Technical Evaluation Report

Draft Waste Incidental to Reprocessing
Evaluation for Closure of
Waste Management Area C,
Hanford Site, Washington

U.S. Nuclear Regulatory Commission
Office of Nuclear Material Safety and Safeguards
Washington, DC 20555-0001

May 2020

Figure 2-3 Distribution of Waste in Tank C-108 Following Modified Sluicing

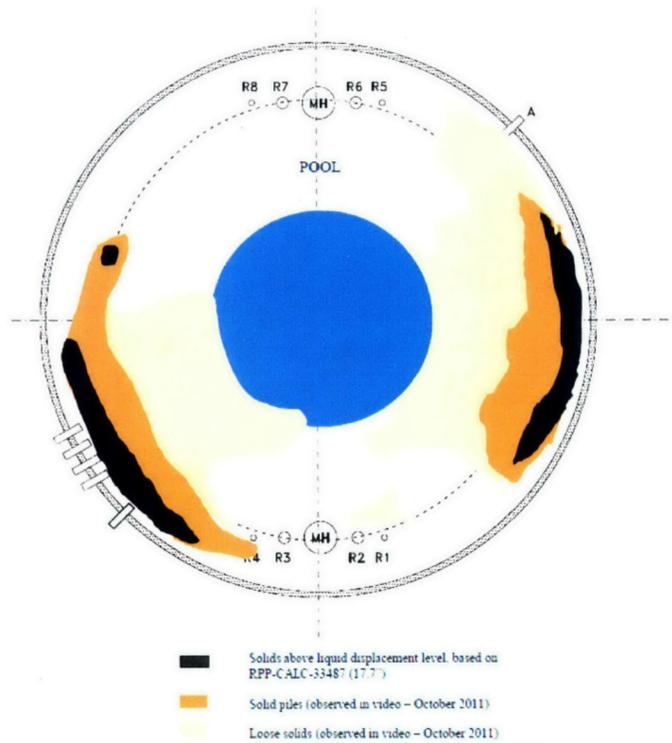
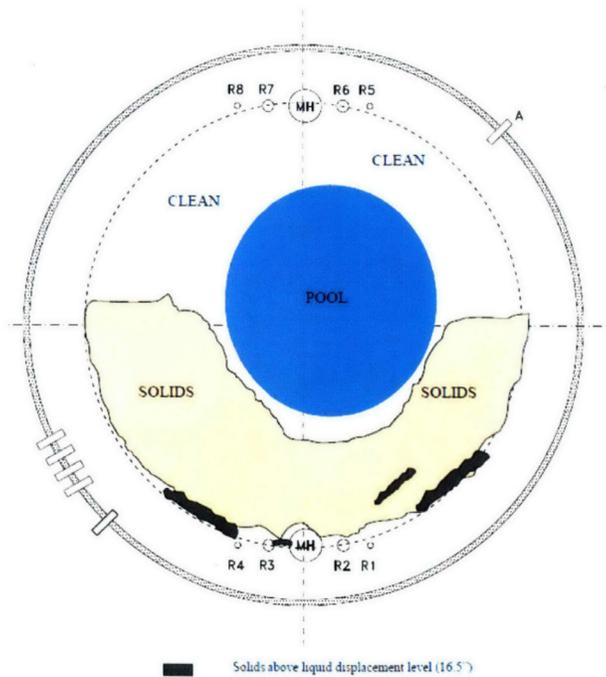
Figures 2-3 and 2-4 show the importance of the number of sluicers in a tank. When two sluicers were available in Tank C-108, the waste closest to the sluicers was removed, resulting in piles of waste on the periphery of the tank at the farthest distance from the sluicers. The motive force that can be applied to the waste to direct it to the pump for removal decreases with increasing distance. After one of those sluicers was plugged, the waste was redistributed to the half of the tank farthest from the operational sluicer. The residual waste in the tank was able to be moved around; however, the waste could not be removed using the technology employed. Similarly, for Tank C-110, DOE indicated in the Draft WIR Evaluation for WMA C that the waste could be mobilized with the sluicers but would settle and could not be easily retrieved with the existing installed equipment.

Figure 3-6 Erosion at the Hanford Barrier from a Severe Thunderstorm

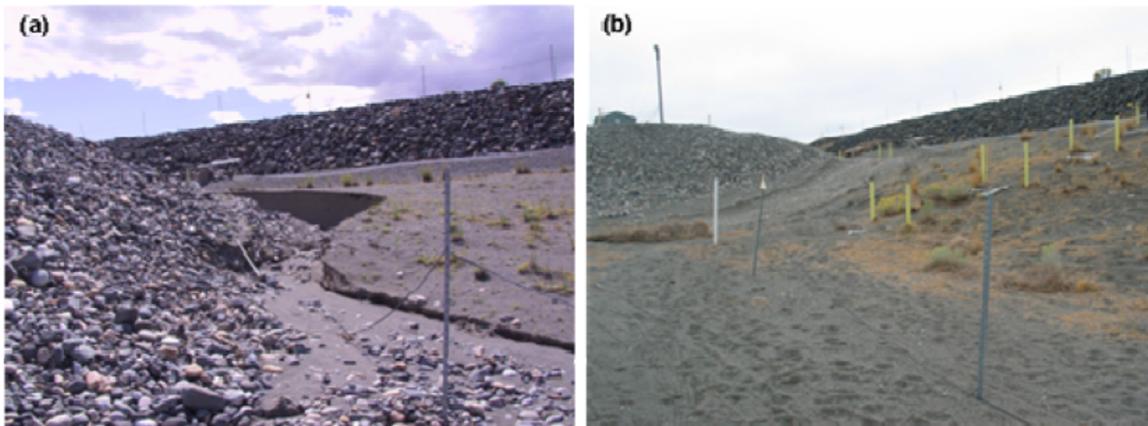
Water erosion has occurred on the Hanford Prototype Barrier as shown in photos from Section 2.2.4 in PNNL-17176 (2007) (shown in Figure 3-6). Severe thunderstorms with sufficient intensity to allow water to collect near the BY Farm eroded a berm, flowed down the northwestern slope of that tank farm, and eroded gravel armor and created a channel over 1 meter (40 inches) deep at the base of the barrier side slope. DOE has emphasized that the erosion was due to runoff from the BY-Tank Farm and not from the cover itself (NRC, 2018d). This episode, however, emphasizes the need for an engineered cover design in line with a PMP analysis. Alternatively, less performance credit for the engineered cover could be prescribed consistent with the expected rates of erosion of a less robust engineered cover design.

Figure 3-16 Sampling Locations for Tank C-110 (left) and Tank C-109 (right)

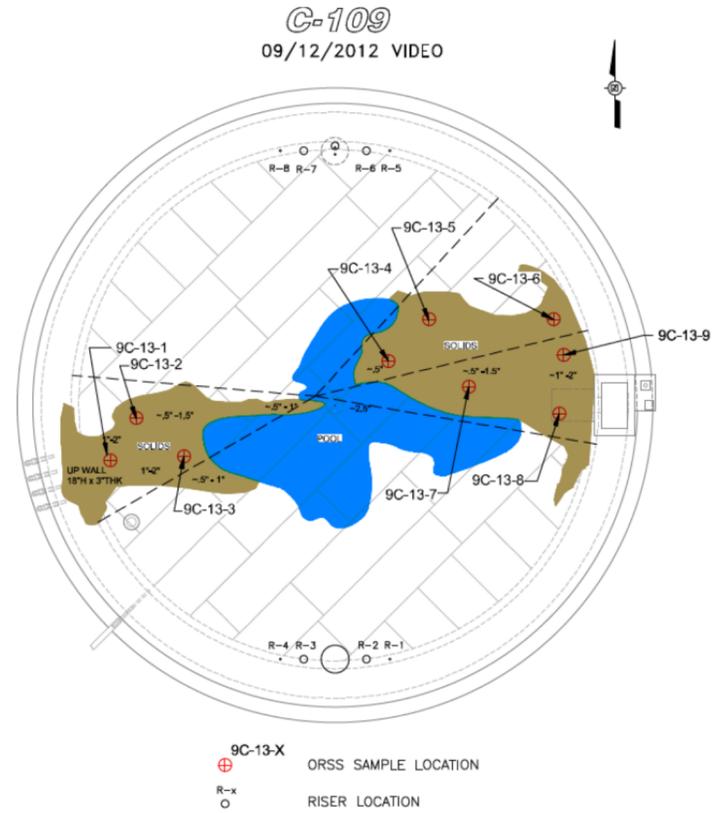
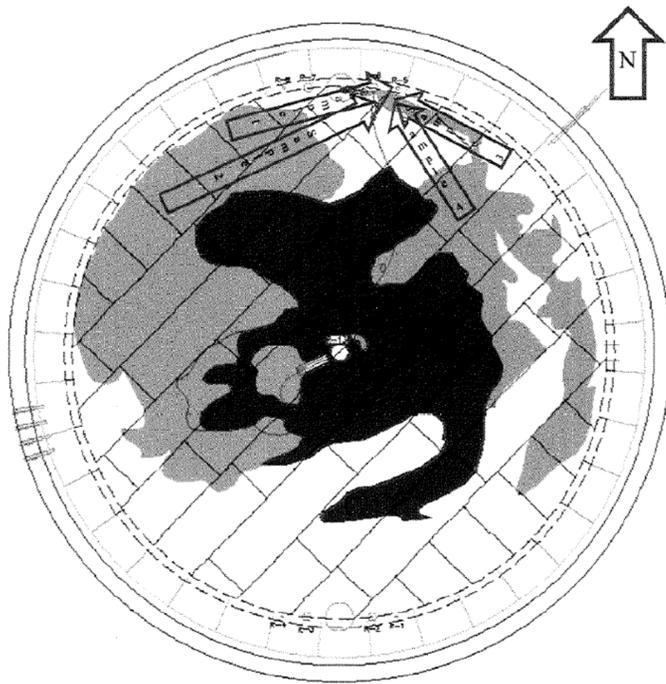
Figure 3-16 shows the sampling locations for Tank C-109 and Tank C-110 (RPP-RPT-55492, 2013); (RPP-RPT-56796, 2014). DOE generally obtains samples from nine locations. However, because the amount of material obtained from each sampling location can be limited those nine samples are composited into three samples. The location of residual waste in the tanks is a strong function of the location of access points (inversely related). Whereas some of the sampling (e.g., C-109) was able to sample the full areal extent of the waste in the bottom of a tank, other sampling was more limited in terms of locations (e.g., C-110). Without performing a validation study by obtaining more samples from a tank and comparing the resultant inventory estimates with the inventory developed from the three samples, the representativeness of the sampling approach cannot be determined.

Figure 3-26 Planar Rectangular Window Containing Six Model Cells for Which the Weighted Average Hydraulic Conductivity was Calculated
 [Figure C-5 in RPP-RPT-58949 (2016)]

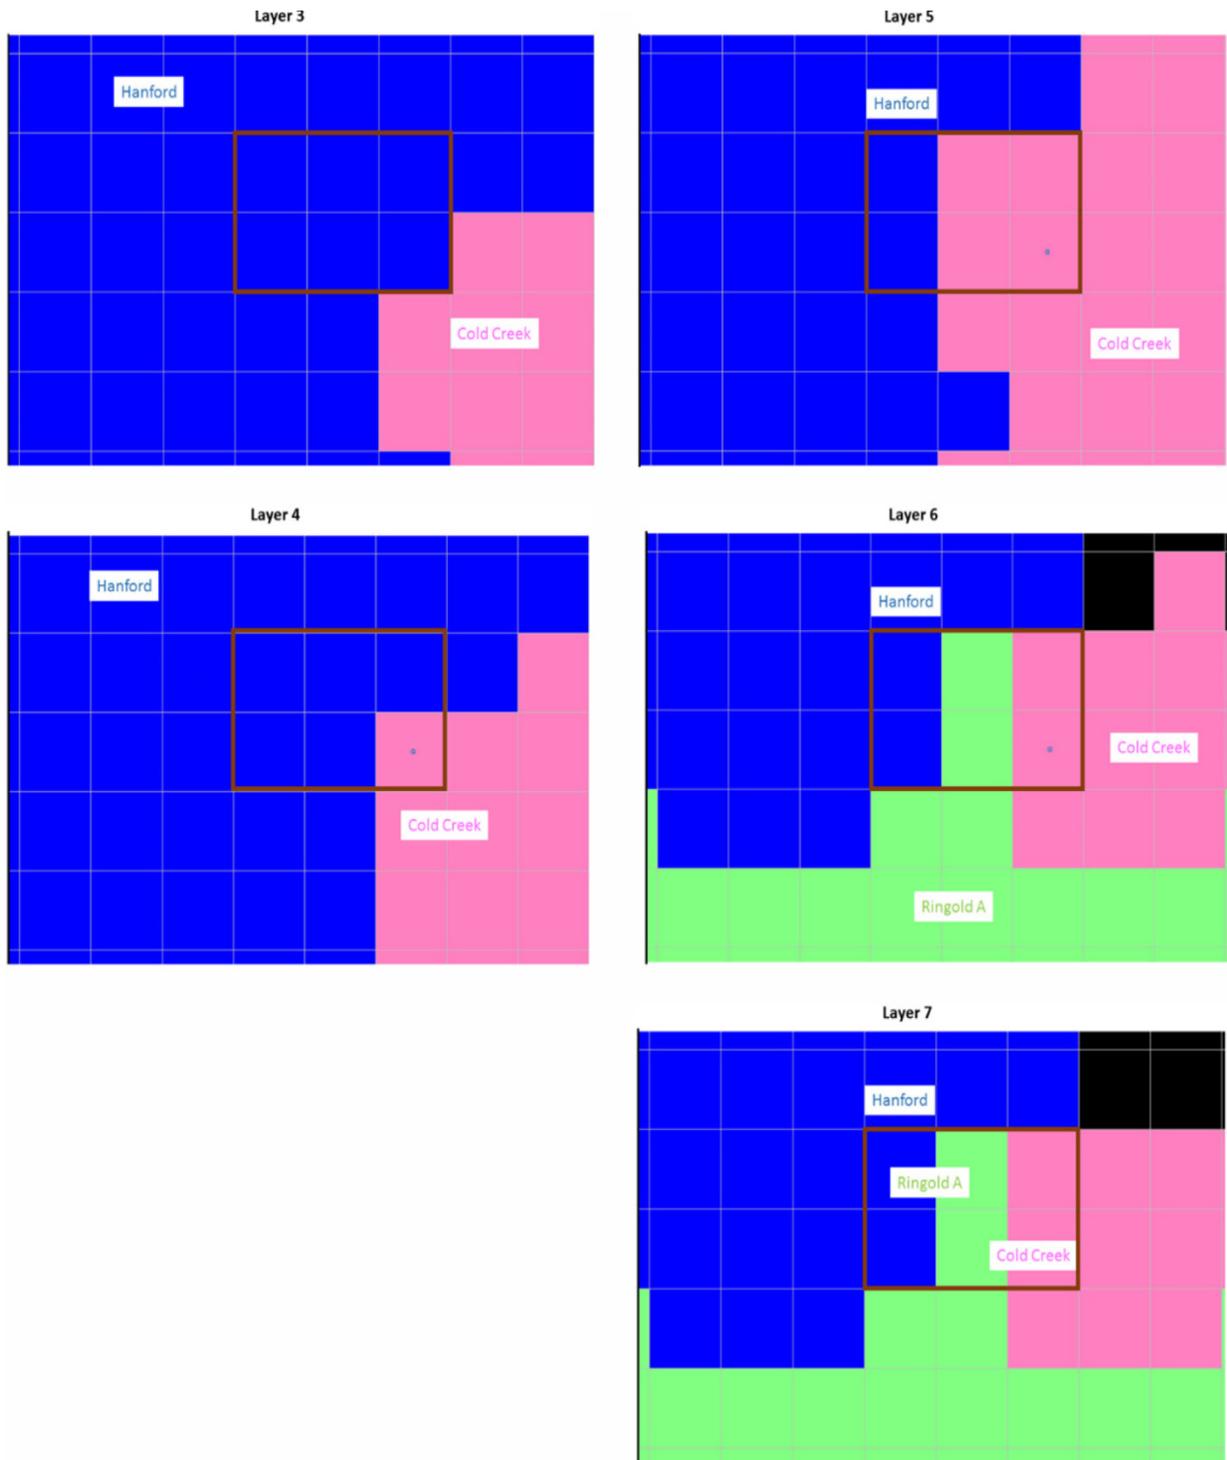
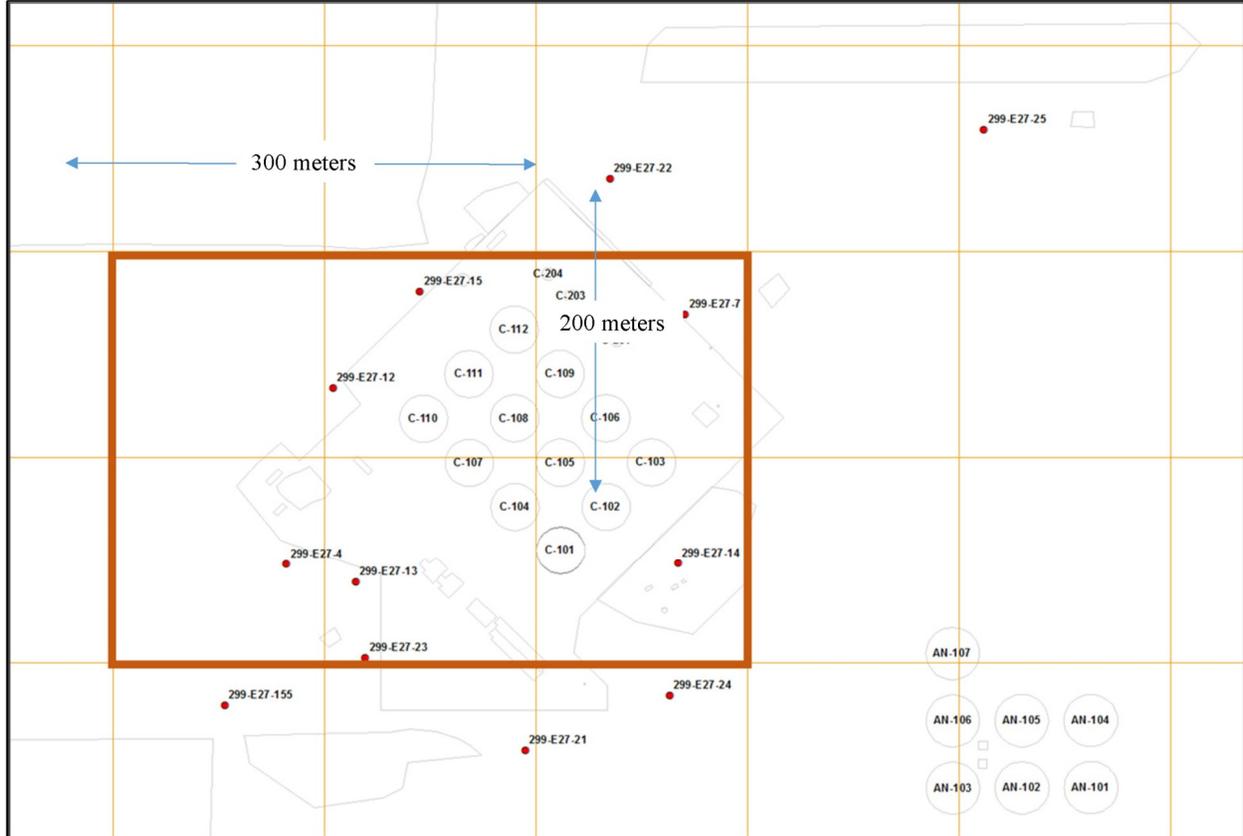
Most of the flow and transport properties used in the WMA C PA by DOE, including the hydraulic gradient, were obtained from results developed from the calibrated CPGWM (CP-47631, 2015). The planar rectangular window, as shown Figures 3-25 and 3-26, contains six model cells. This rectangular window was used by DOE to calculate the hydraulic conductivity value of the STOMP WMA C saturated model layer. The C-Tank Farm with single-shell tanks is visible in the background of Figure 3-25. Much of the WMA C is encompassed within the rectangular window as is an area to the east of WMA C. The area is equivalent to two CPGW model cells. However, this additional area to the east is not representative of the flowpath used by DOE to model contaminant concentrations. This flowpath is 100 m (328 ft) downgradient from the fence line at the POC. An alternate approach that would encompass this flowpath would be to move the planar rectangular window containing the six model cells to the east to

encompass this critical flowpath while still including WMA C (see Figure 3-26). Moving the window to the east would, however, change the representation of the hydrogeological units within that window (see Figure 3-25) based on the hydrogeologic framework of the CPGW model. The Cold Creek unit would be represented by a greater number of model cells while the Hanford units would be less represented. This would change the values used to obtain the effective hydraulic conductivity for the aquifer within the WMA C STOMP model. Using this averaging approach and following the same procedure are described in Section 3.7.1, the rounded calculated layer-thickness-weighted hydraulic conductivity obtained would be 5700 m/d (18,700 ft/d), roughly half the value shown in Table 3-13 (i.e., 11,000 m/d). As concentrations in the water well change approximately linear with the hydraulic conductivity in this model, this would result in approximately doubling the dose.

Figure 3-27 Field-scale Dispersivity in the Saturated Zone as a Function of Scale
 [Gelhar et al., 1992]

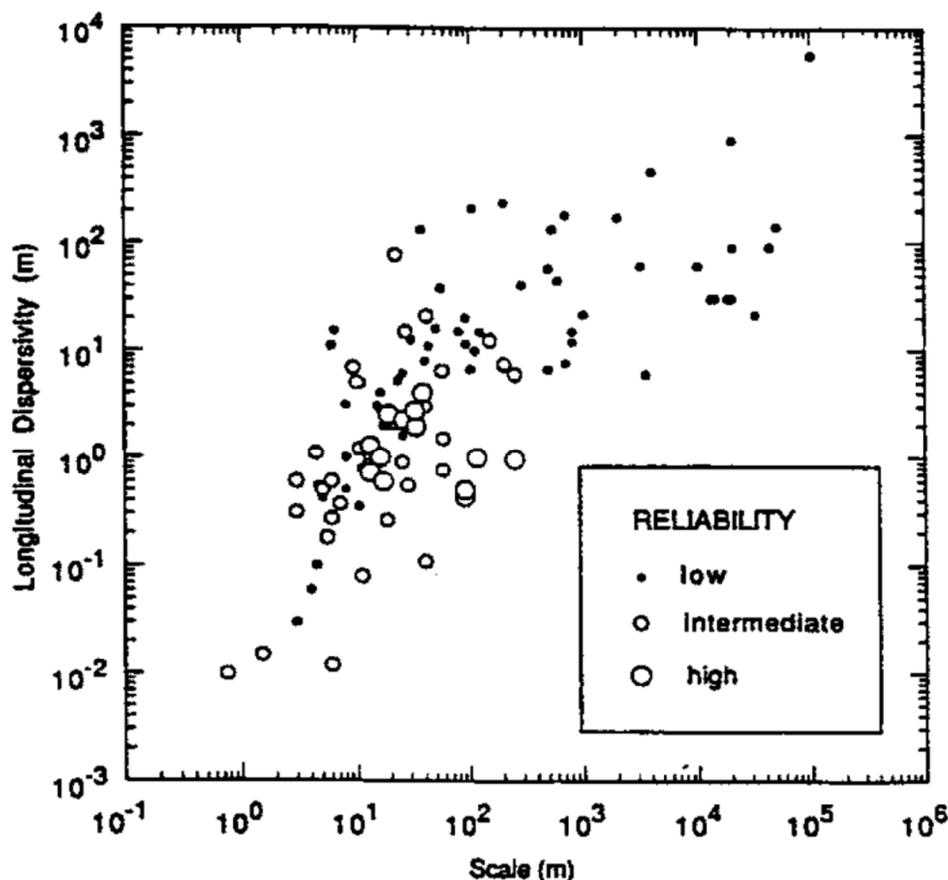
Field-scale dispersivity was rated relatively high in the results of the uncertainty analysis, as seen in Table 8-13 in the WMA C PA. The range in saturated zone dispersivity at the scale of the WMA C model is estimated by DOE to be from 1 m to 20 m (3.3 ft to 65.6 ft). However, as can be seen in the Figure 3-27, most data points with high reliability are 5 m (16 ft) or less, possibly indicating that 10.5 m (34.4 ft) is not a representative value of those values with high reliability. The range of dispersivity values used by DOE in the uncertainty analysis may be skewed towards the high end. The calculated values of the three general relationships for saturated longitudinal dispersivity are equal to 17 m, 6 m, and 3.5 m, or an average of 8.8 m or a median of 6 m. Since this parameter is ranked relatively high in importance at 1,000 years and 3,400 years after closure, the technical basis for the base case value of 10.5 m (34.4 ft) needs to be adequate or the range of values used in the uncertainty analysis needs to be sufficiently broad to account for the uncertainty. The base case value assigned by DOE lacks adequate technical and model support.

Figure 3-38 Combined Failure of Multiple Safety Functions

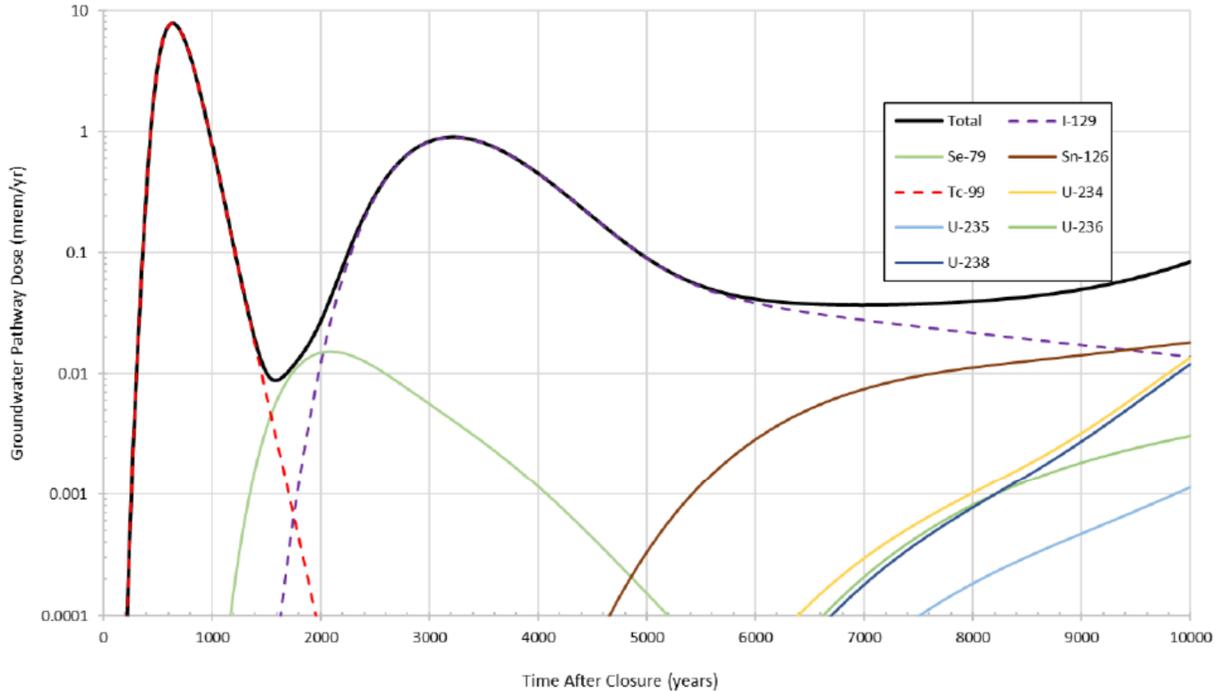
The results of the analysis are shown in Figure 3-38. The peak dose within the compliance period has increased to approximately 0.08 mSv/yr (8 mrem/yr) from 4×10^{-6} mSv/yr (4×10^{-4} mrem/yr) (a factor of 20,000 increase). NRC agrees that some aspects of the evaluation are pessimistic, but the analysis is useful to support regulatory decision-making. In a system model with numerous uncertainties that were not evaluated in the probabilistic system model analysis, the impact of those uncertainties cannot be determined with one-at-a-time evaluations; it is conceptually flawed to use one-at-a-time evaluations to evaluate the global impact of uncertainties. This approach should not be used in future waste evaluations (Recommendation #55). NRC's conclusions about the appropriateness of uncertain evaluations are based on the system model and the global uncertainty evaluation case evaluated in response to NRC's RAI. The safety function analyses are useful to evaluate and understand the role individual safety functions may have, but safety function analysis is most useful if it is done with a full or partial factorial analysis, as was done previously by the NRC (CNWRA, 2011).

Figure 4-1 Chronic Intruder Doses for the CR-Vault

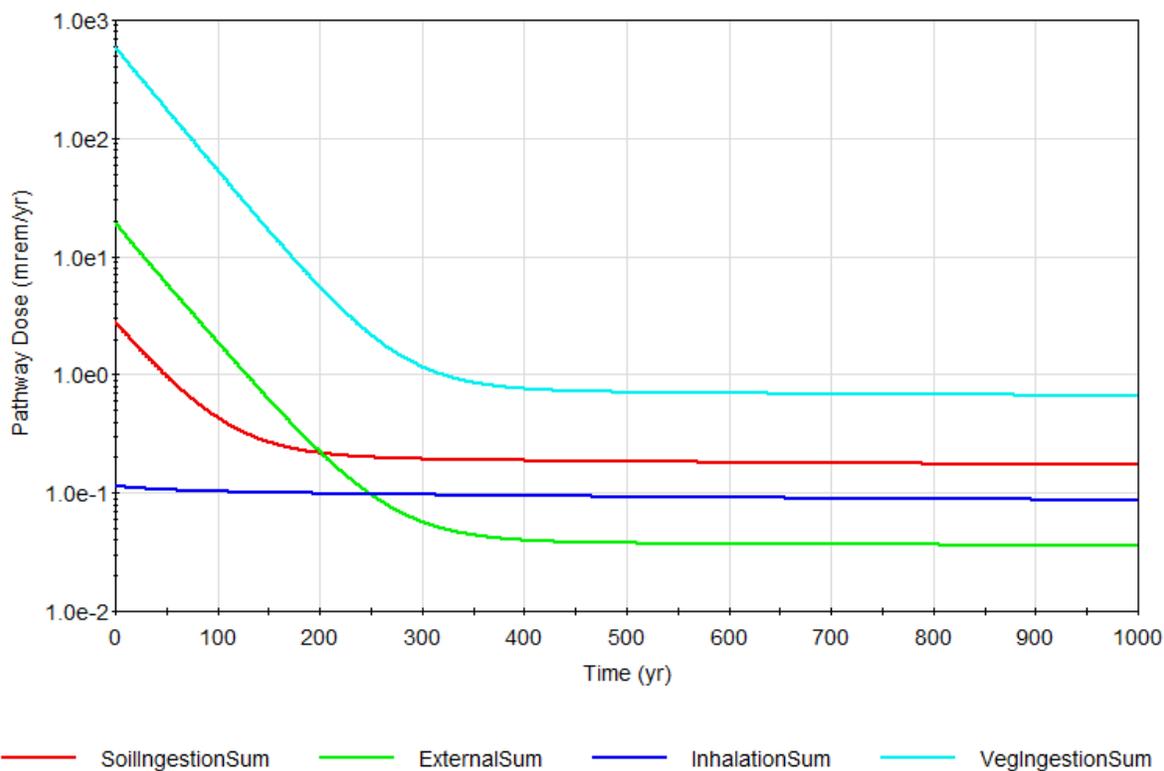
Essentially, the extra factor of 4 from double counting of the NRC dilution factor is offset by the assumption regarding cuttings mixing. Figure 4-1 is the intruder dose plot for the chronic intruder for the 244-CR vault. The doses drop off very rapidly with time from the decay of ⁹⁰Sr and ¹³⁷Cs. Doses during the first 100 years are not possible due to active institutional controls being in place.
